ABBREVIATED PLAT AGENDA CONFERENCE ROOM 110 350 EAST DAHLIA AVENUE, PALMER

STAFF REVIEW AND RECOMMENDATIONS
PUBLIC HEARING
SEPTEMBER 14, 2022

ABBREVIATED PLAT: CLARKE ESTATES
LEGAL DESCRIPTION: SEC 22, T17N, R02W, SEWARD MERIDIAN AK
PETITIONERS: ANC PROPERTIES, LLC
SURVEYOR/ENGINEER: KEYSTONE SURVEYING & MAPPING/HOLLER ENGINEERING
ACRES: 5.52 ± PARCELS: 4
REVIEWED BY: MATTHEW GODDARD CASE #: 2022-126

REQUEST: The request is to create four lots from Parcel #1, MSB Waiver #78-28-PWm, recorded as Waiver Resolution #78-78w, to be known as **CLARKE ESTATES**, containing 5.52 acres +/- . The property is located west of S. Vine Road, east of S. Vale Avenue and directly north of W. Hollywood Road; within the SE ¼ Section 22, Township 17 North, Range 02 West, Seward Meridian, Alaska.

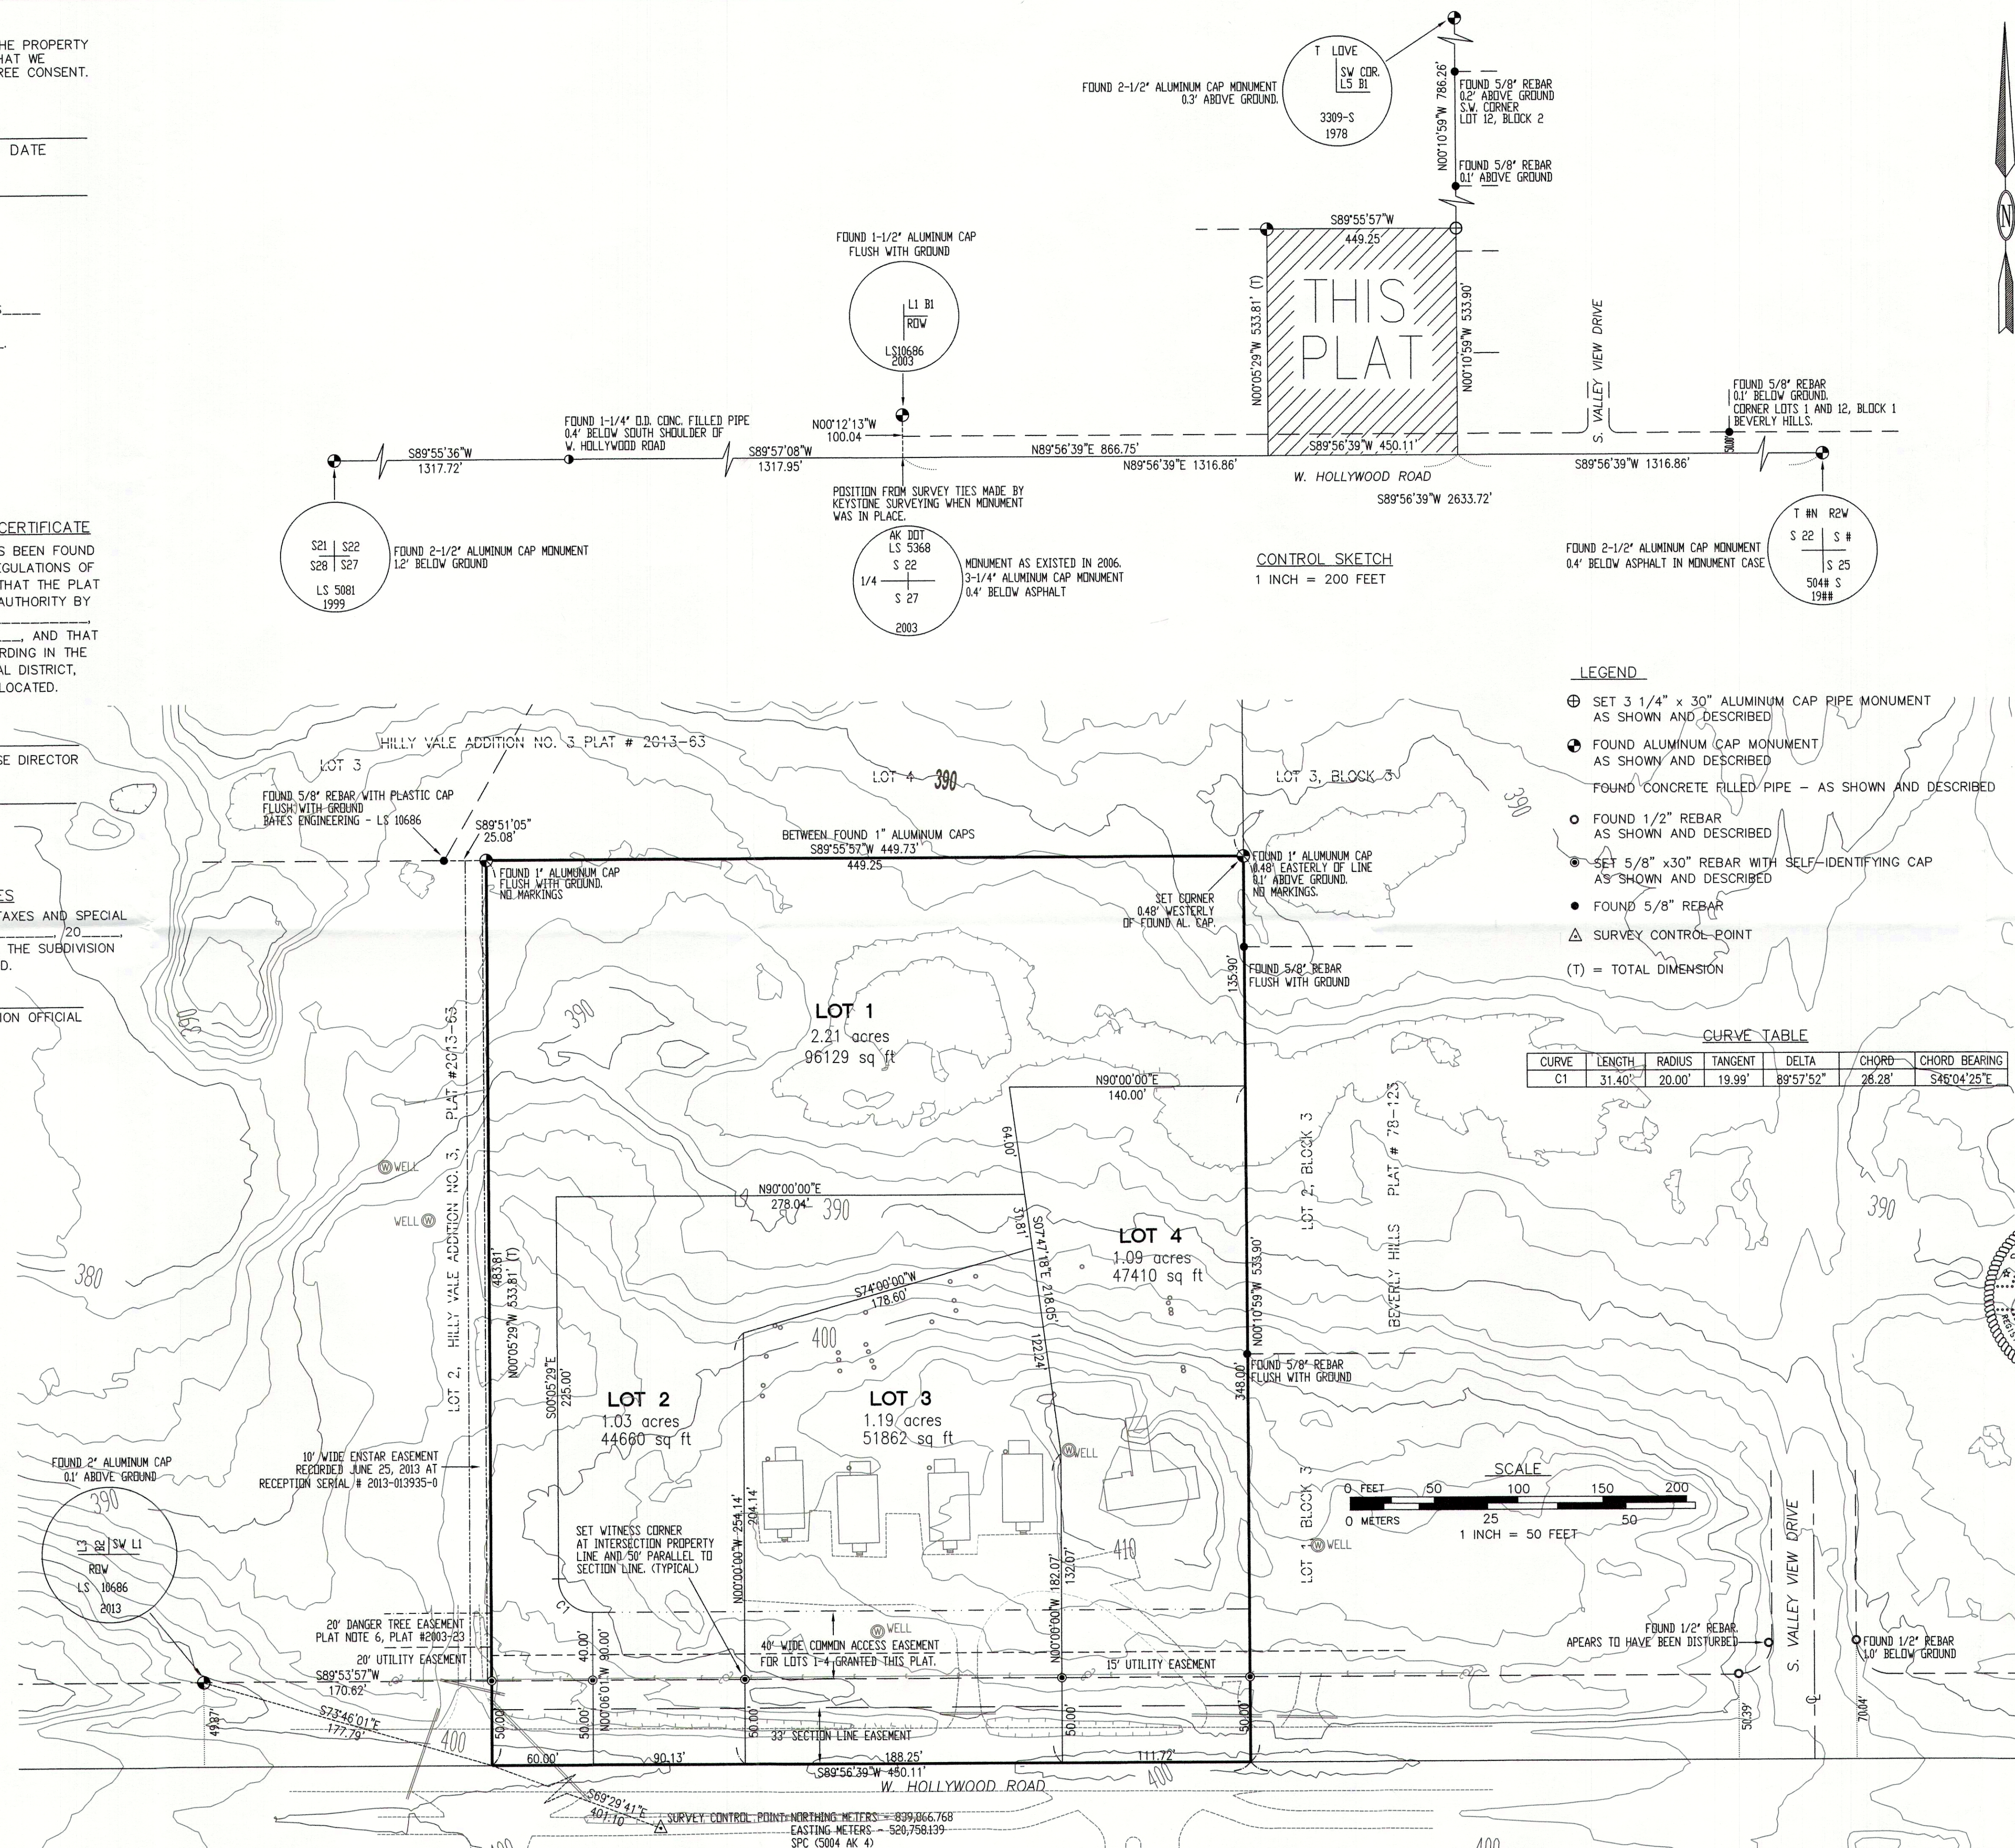
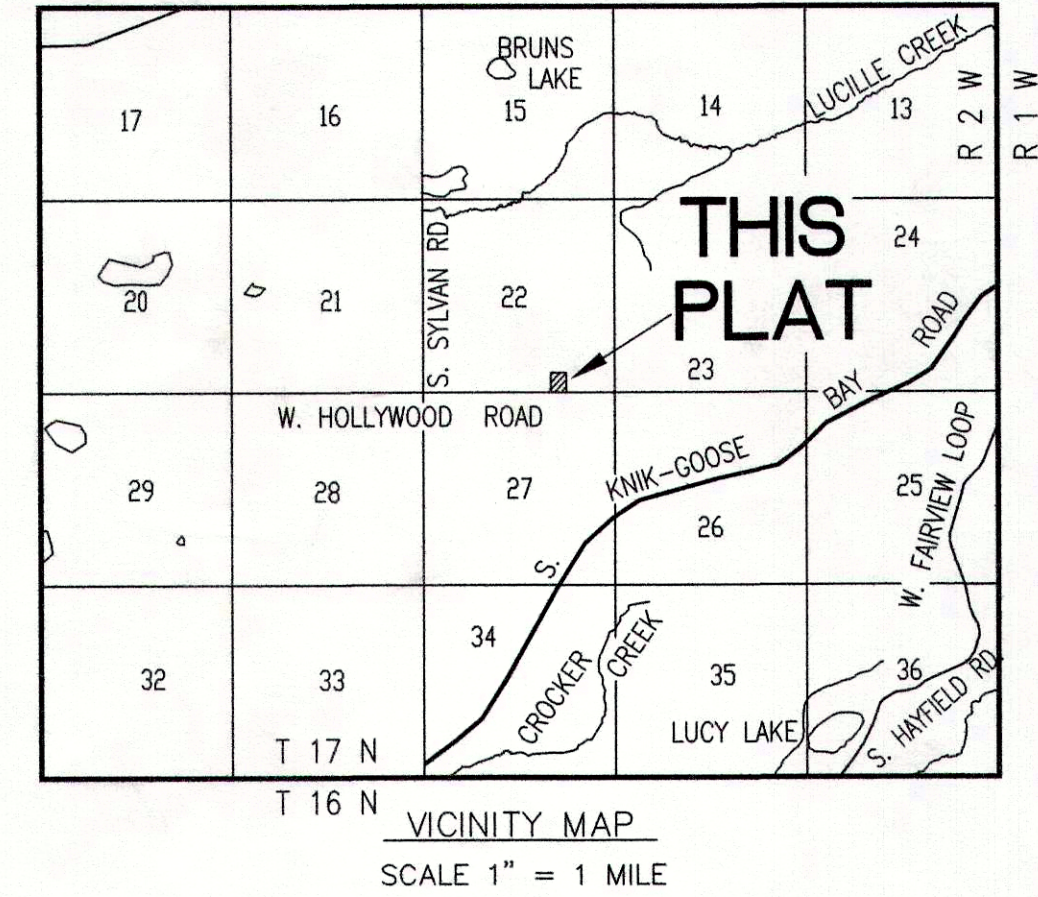
ADOT&PF (**Exhibit C**) requests 50' Right-of-Way dedication for Hollywood Road. *Staff notes that this is an abbreviated plat and cannot dedicate Right-of-Way.* Shared access for Lots 1-4 is requested. *Staff notes that a plat note will be required limiting access to a single driveway onto W. Hollywood road. This is shown at Recommendation #5.*

MSB DPW (**Exhibit E**) notes that the easternmost driveway should be removed prior to the recordation of this plat (See Recommendation #6). Proposed Lot 3 will require a multifamily permit (See Recommendation #4).

MSB Development Services (**Exhibit G**) notes that this Platting action will create a dwelling unit density on proposed Lot 3 which requires a multifamily permit in accordance with MSB 17.73.

- **Susitna Flats Master Plan**
 - Request Lot 1 and 2 to share access. Lot 3 and 4 to share access.
 - May want to consider language to remove the Perpetual Driveway Easement upon establishment of PUE for Lots 3 and 4.
- **Clarke Estates**
 - **Request 50' Right of Way dedication for Hollywood Road.**
 - **Request shared access Lots 1-4 to Hollywood Road.**

The easternmost existing driveway should be obliterated prior to recordation of the plat.
Obtain multi-family development permit for L3, if required by code.

The proposed platting action will create a dwelling unit density (proposed Lot 3) which requires a multifamily permit in accordance with MSB 17.73. Please let me know if you have any questions. Thank you.

Our concern is that these new lot lines may create setback violations with the existing structures.

3. Pay postage and advertising fees.
4. Apply for a multi-family permit and provide Platting Staff a copy of the application.
5. Add a Plat Note stating that only one access shall be allowed onto W. Hollywood Road unless otherwise approved by the permitting authority.

6. Reclaim one of the existing driveways and provide proof to the Platting Staff of its removal.
7. Show all easements of record on final plat.
8. Submit recording fees, payable to Department of Natural Resources (DNR).
